HISTORIC AND DESIGN REVIEW COMMISSION

HDRC CASE NO: 2021-317
COMMON NAME: MLK Park
ADDRESS: 3503 MARTIN LUTHER KING DR
LEGAL DESCRIPTION: NCB 10677 P-5A, GIS 80.38 AC
ZONING: R-4
CITY COUNCIL DIST.: 2
APPLICANT: Jordyn Patrias/City of San Antonio Department of Arts & Culture
OWNER: CITY OF SAN ANTONIO
TYPE OF WORK: Public artwork
APPLICATION RECEIVED: June 24, 2021
60-DAY REVIEW: Not applicable due to City Council Emergency Orders
CASE MANAGER: Rachel Rettaliata

The applicant is requesting a Certificate of Appropriateness for approval to install public art.

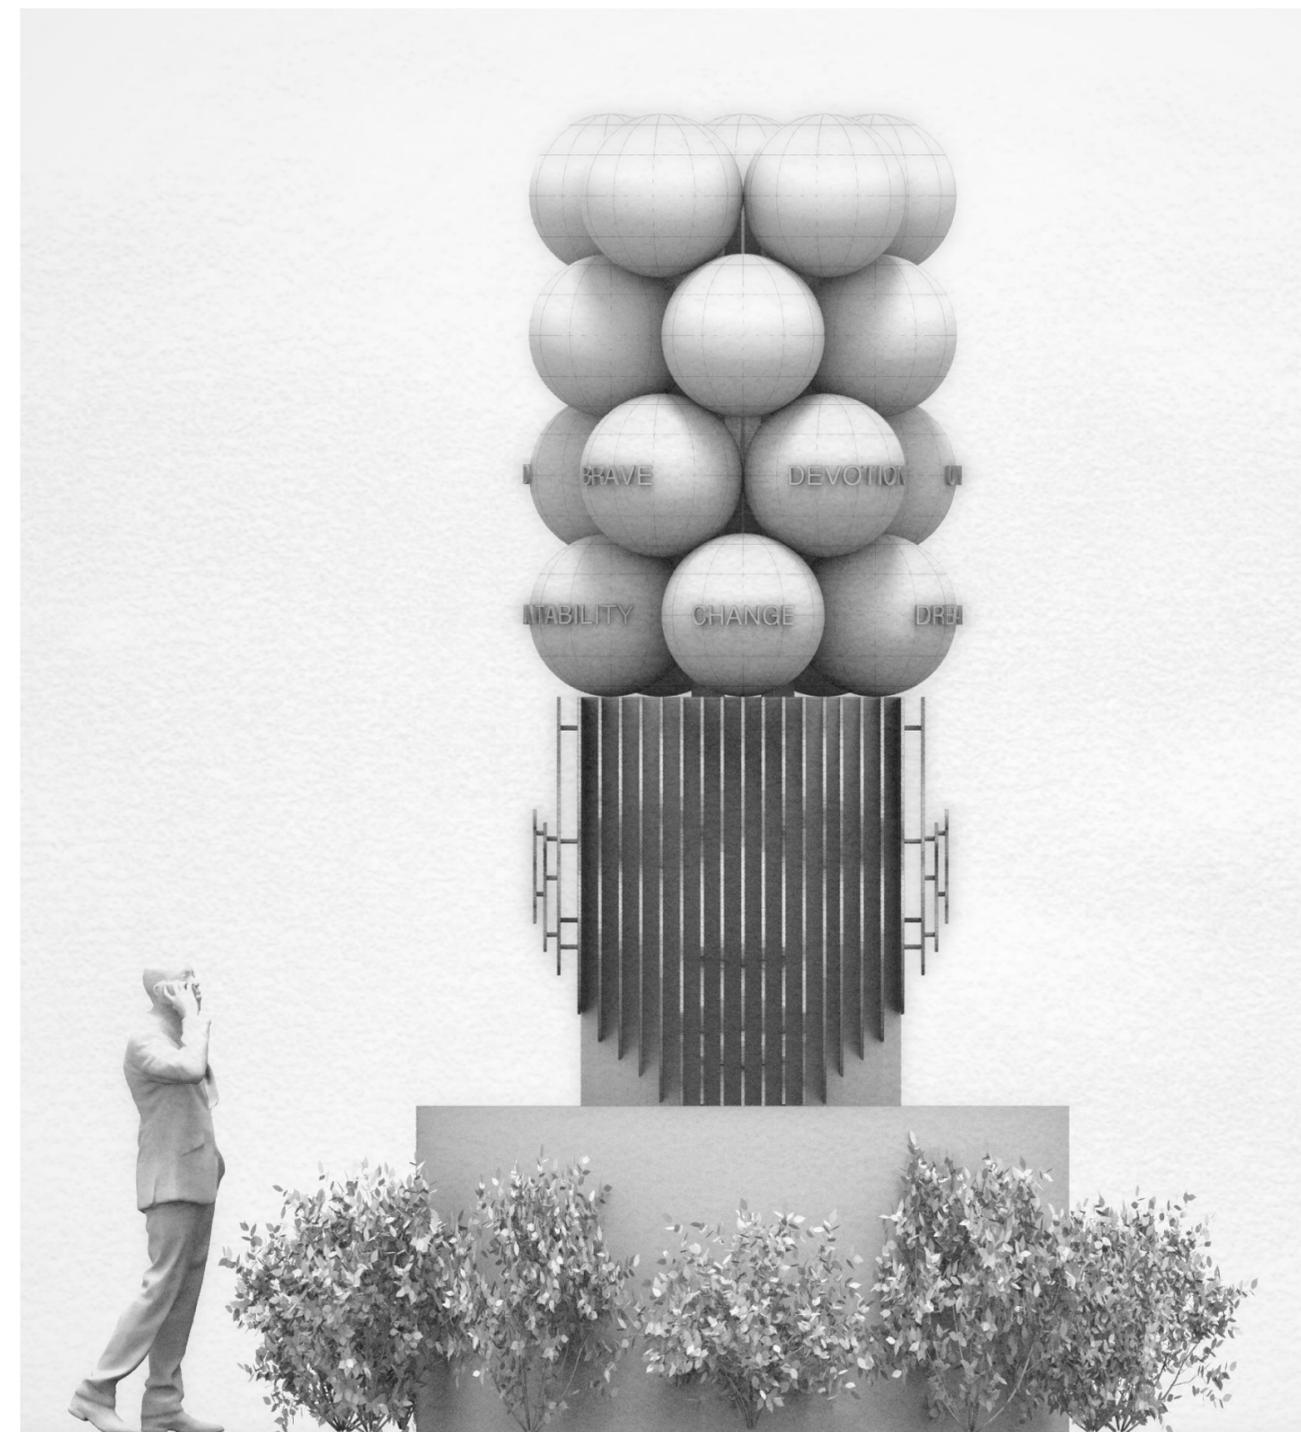
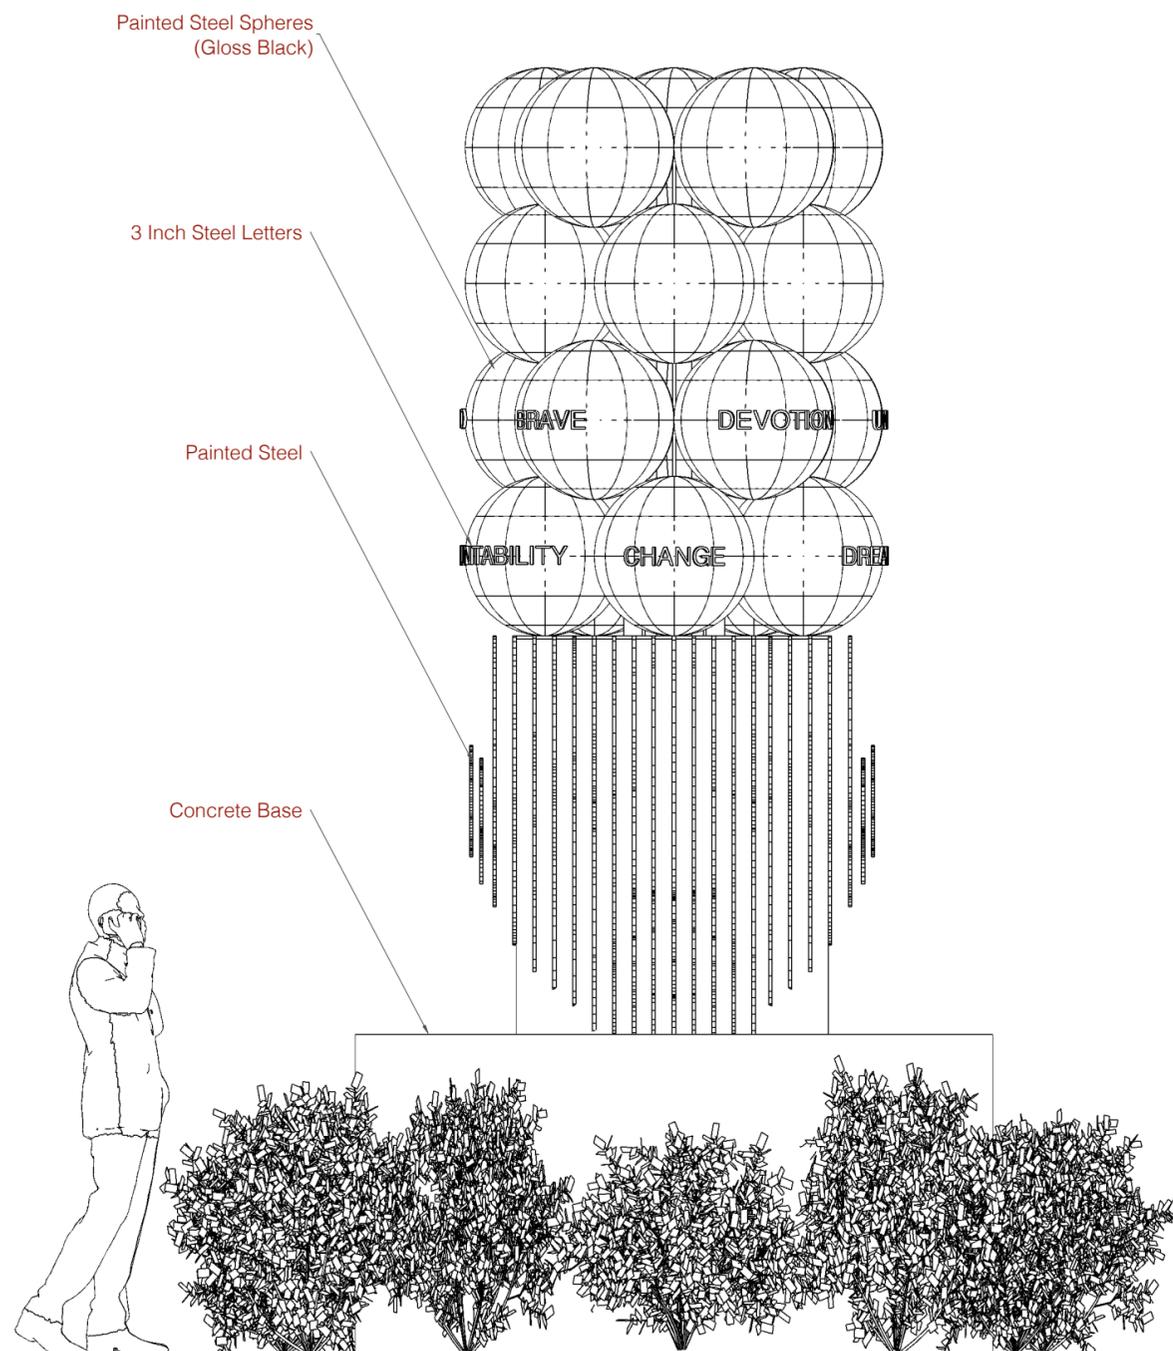
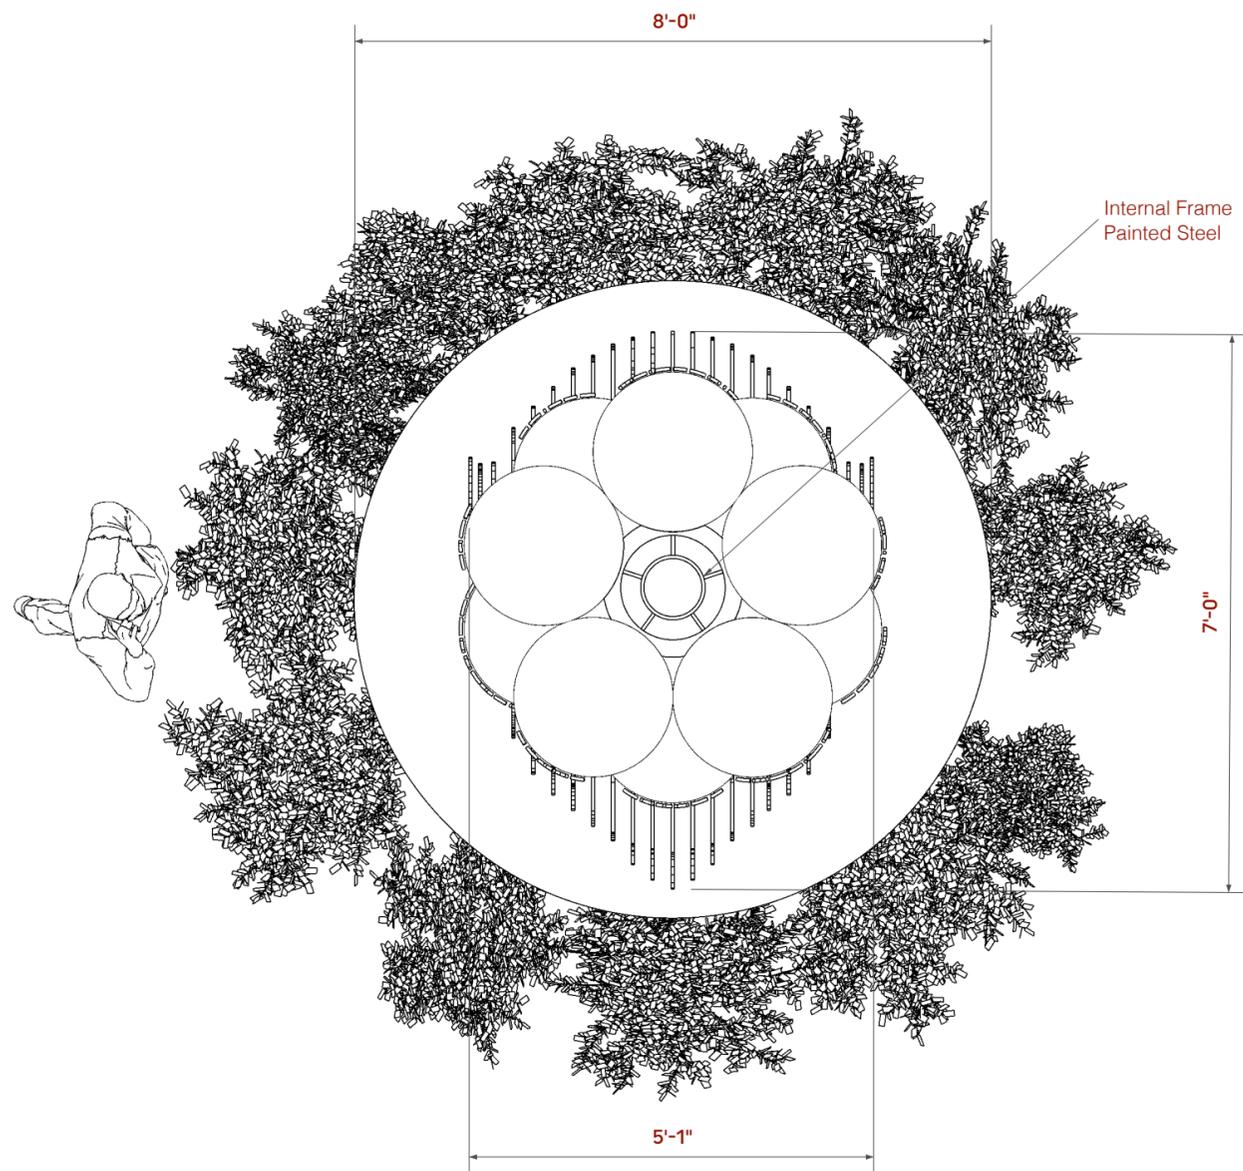
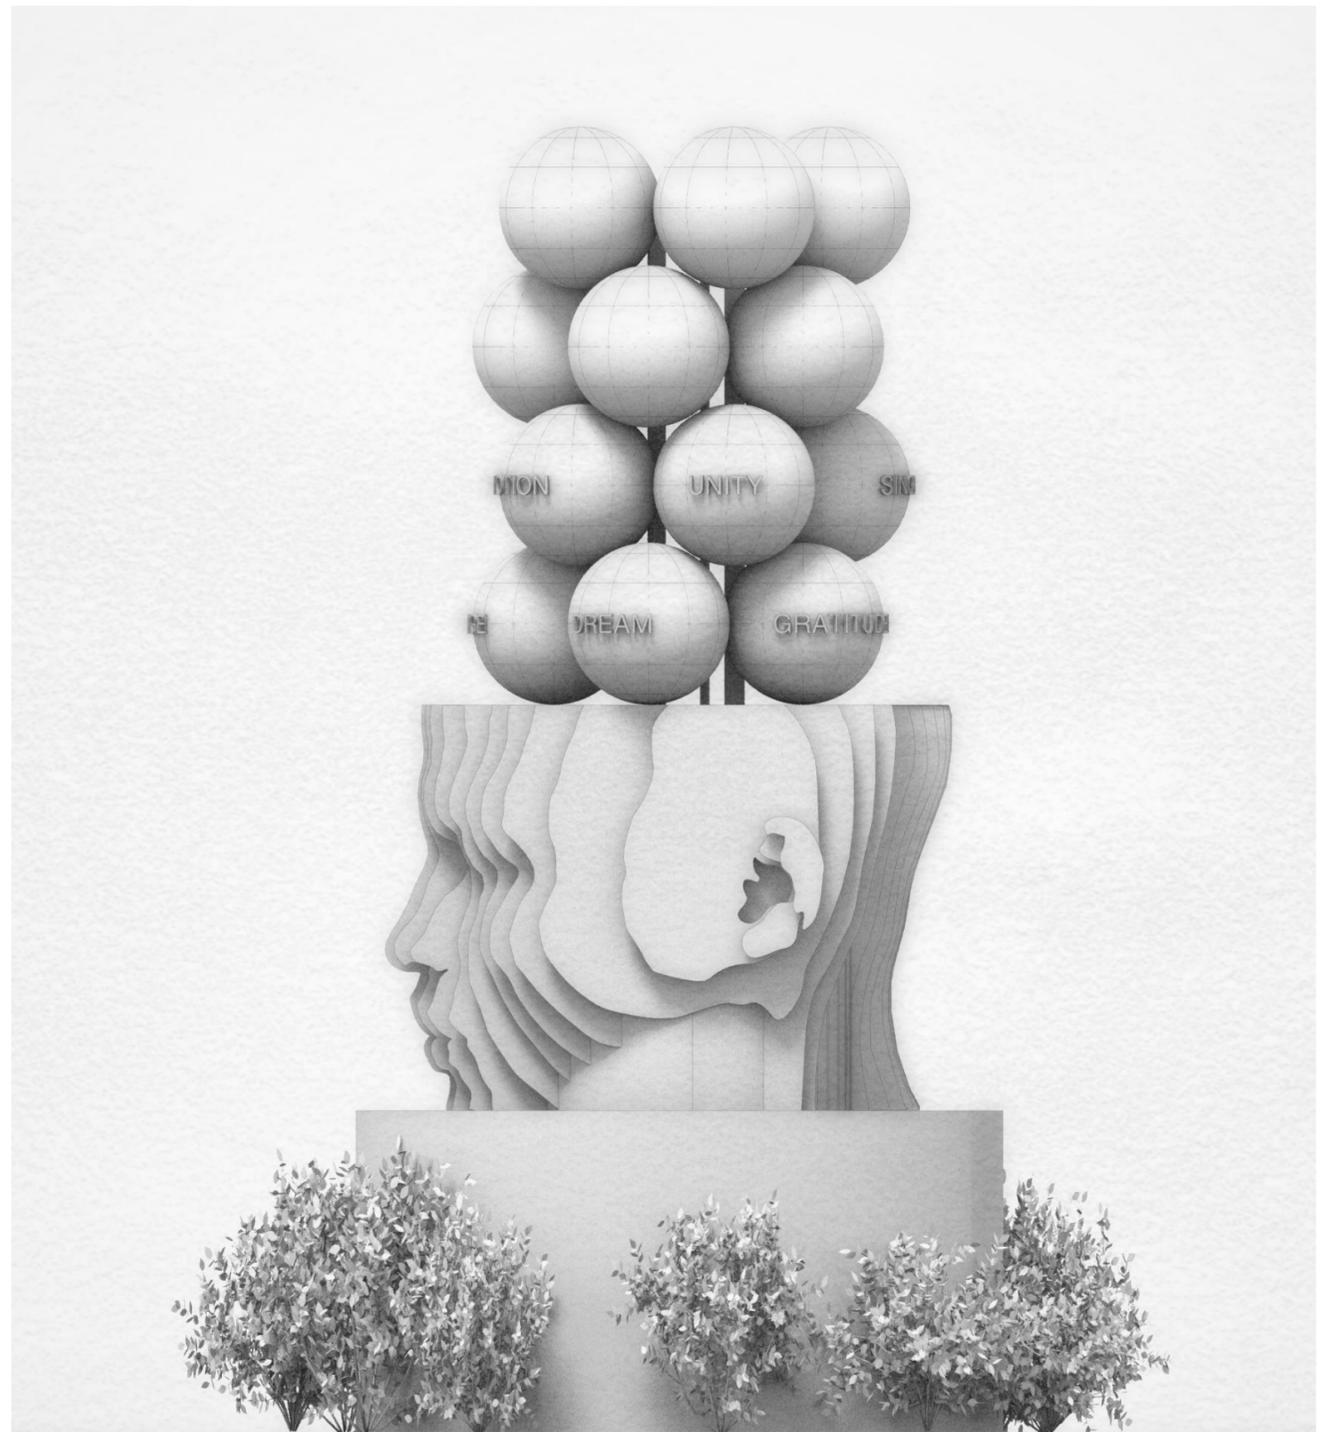
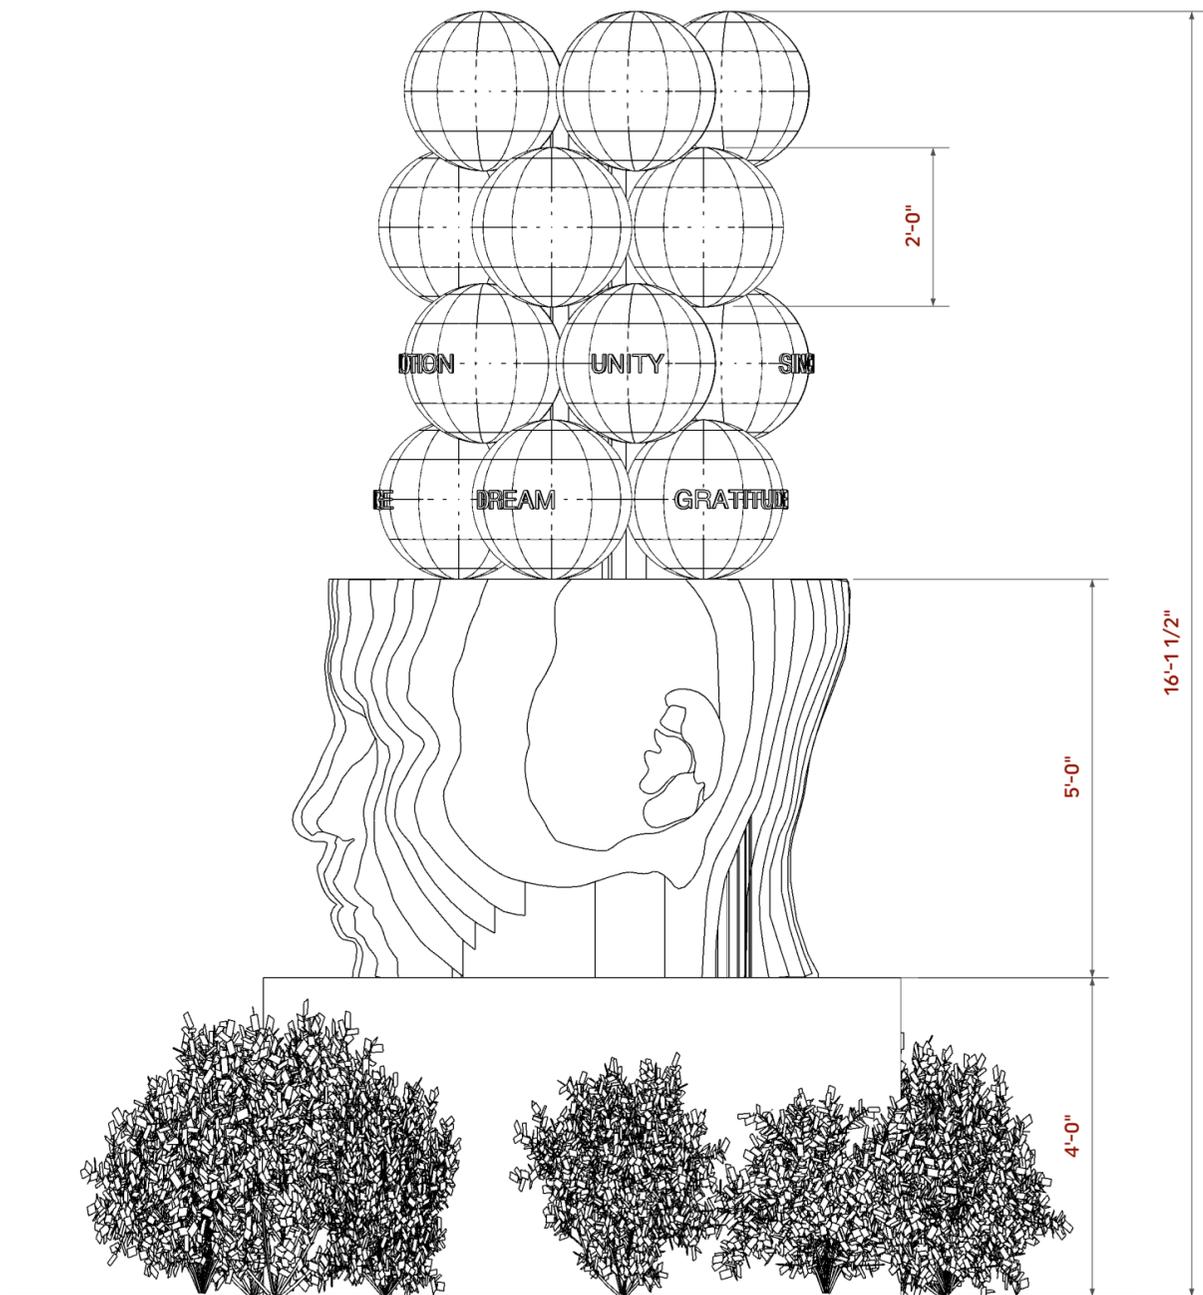
- b. PUBLIC ART – The applicant has proposed to install a Public Art Sculpture titled *Spheres of Reflection* by local artist Kaldric Dow. The sculpture pays homage to Black and African American Culture, and proper representation of culture. The sculpture is proposed at 16.5 feet tall and will weigh 10,000 pounds. The proposed sculpture will feature purposefully rusted mild steel coated with epoxy and anti-graffiti coating, steel painted gloss black, 3-inch-tall steel letters, and a foundation of unfinished concrete. The sculpture will be located inside of the park entrance, adjacent to the Park parking lot, off of Martin Luther King Drive and will be highly visible from the public right-of-way. The Department of Arts & Culture's project schedule includes community engagement, which will be completed in July 2021. The installation is scheduled to be completed in December 2021. Staff finds the proposal appropriate.

Staff recommends approval based on findings a through c.

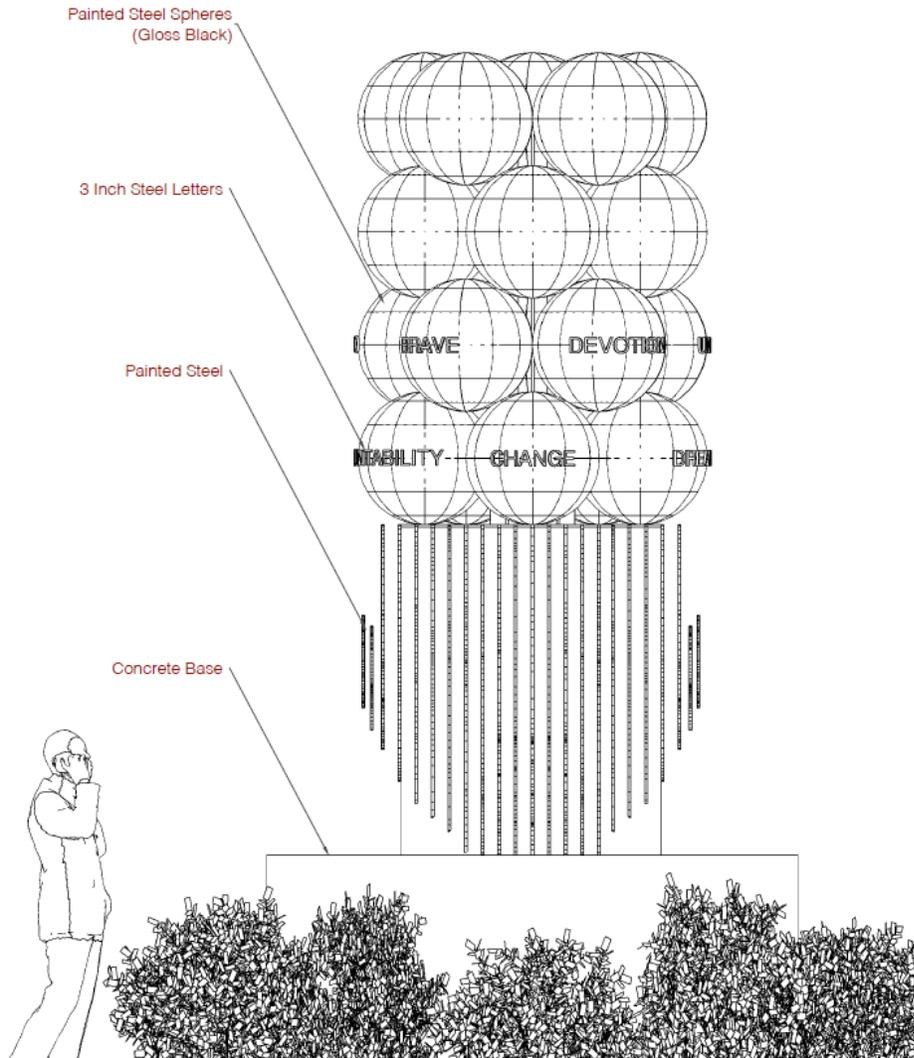
- c. LANDSCAPING – The applicant has proposed to install plantings at the base of the sculpture. At this time, the landscaping is not finalized, and the Department of Arts & Culture will be working with Parks & Recreation to determine plantings that are appropriate for the sculpture and the surrounding area. Staff finds the proposal generally appropriate.
